RENESAS TECHNICAL UPDATE

Product Category	MPU & MCU	Document No.	TN-16C-A194A/E	Rev.	1.00
Title	Errata to R32C/152 Group Hardware Manual	Information Category	Technical Notification		
Applicable Product	R32C/152 Group	Lot No.	Reference Document	R32C/152 Group Hardware Manual Rev. 1.03 (REJ09B0504-0103)

This document describes corrections to the R32C/152 Group Hardware Manual, Rev. 1.03.
The corrections are indicated in red in the list below.

Figure 24.32 LINi_j Interrupt Block Diagram (i = 0, 1; j = 0 to 3)

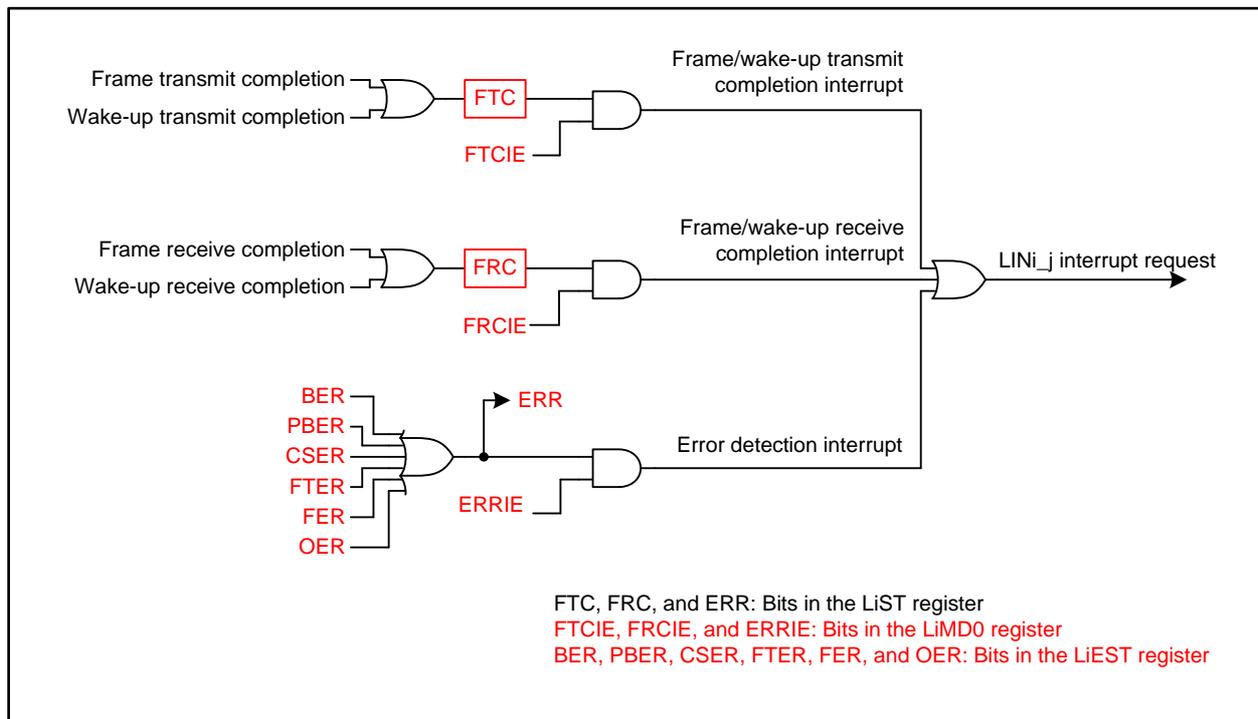
- Page 434 of 639, description for Detecting Condition for Input signal low detection in Table 24.8 is changed as follows:
 “When the falling edge of input signal at the LINi_jIN pin is detected with the setting of the LDE bit in the LiMD0 register to 1 (Input signal low detection enabled), or when setting the LDE bit to 1 while the LINi_jIN pin is low.”
- Page 435 of 639, value range “; j = 0 to 3” in the title of Table 24.9 is deleted.
- Page 437 of 639, description in lines 9 to 10 of 24.11 is added as follows:
 “The respective interrupt request is output when the corresponding flag in the LiST register becomes 1 while the corresponding bit in the LiMD0 register is set to 1 (interrupt enabled). No new interrupt request is generated by the other sources if any of them is 1 since multiple interrupt sources are aggregated.”
- Page 437 of 639, Figure 24.32 is corrected as follows:

Figure 24.33 LINi Low Detection Interrupt Block Diagram (i = 0, 1)

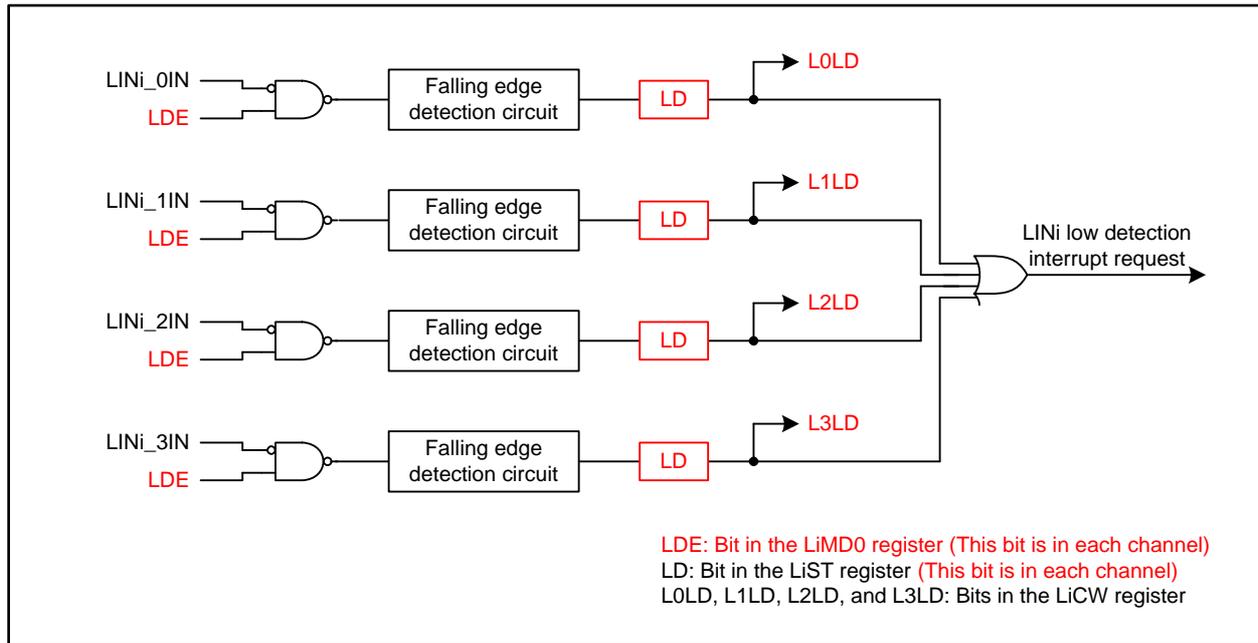
•Page 438 of 639, Figure 24.33 is corrected as follows:

Figure 27.2 Addresses for ID Code Stored

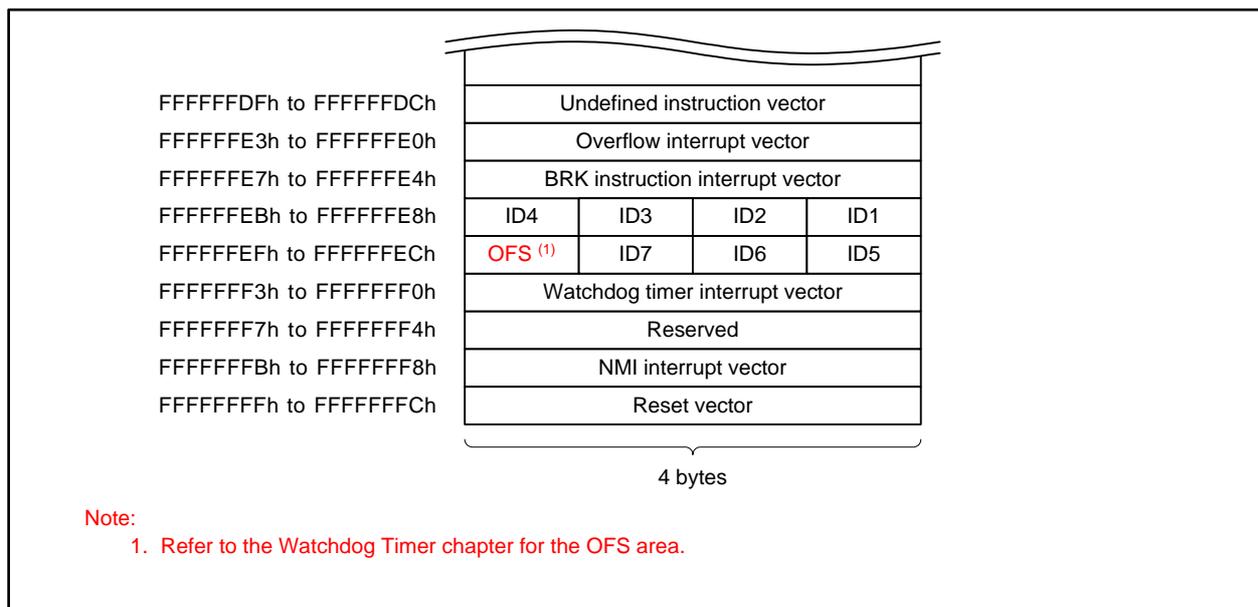
•Page 543 of 639, Figure 27.2 is corrected as follows:

Figure 27.13 Read Timing

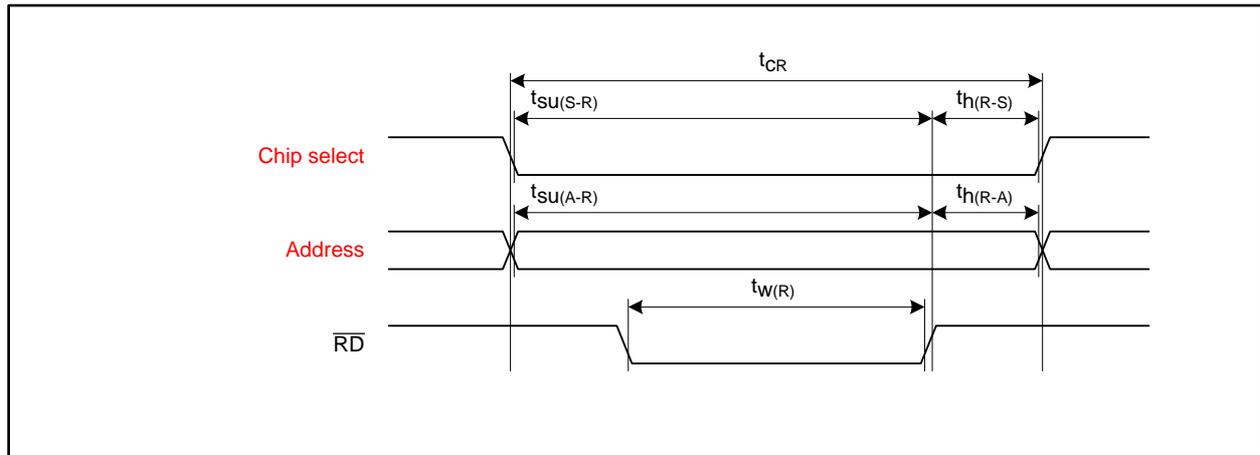
- Pages 552 and 554 of 639, descriptions in Figures 27.13 and 27.14 are corrected as follows:

Figure 29.5 Flash Memory CPU Rewrite Mode Timing

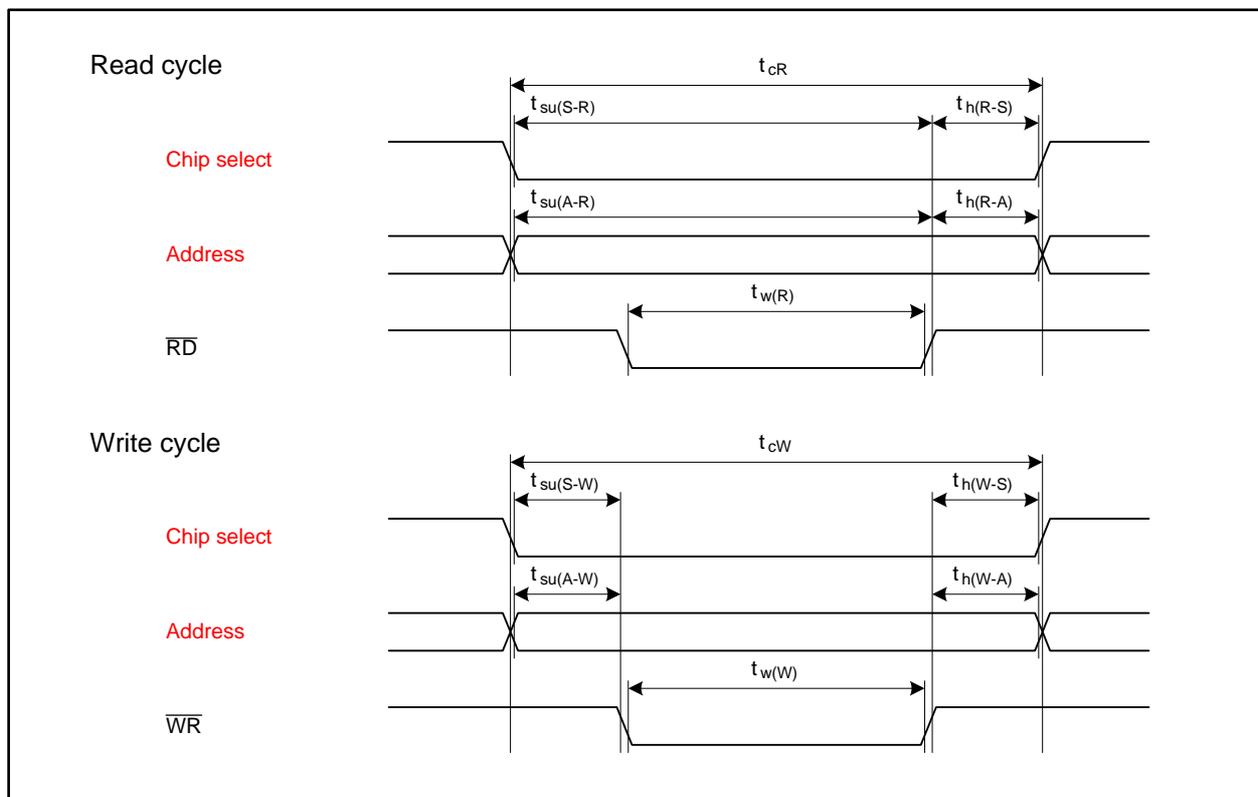
•Page 591 of 639, descriptions in Figure 29.5 are corrected as follows:
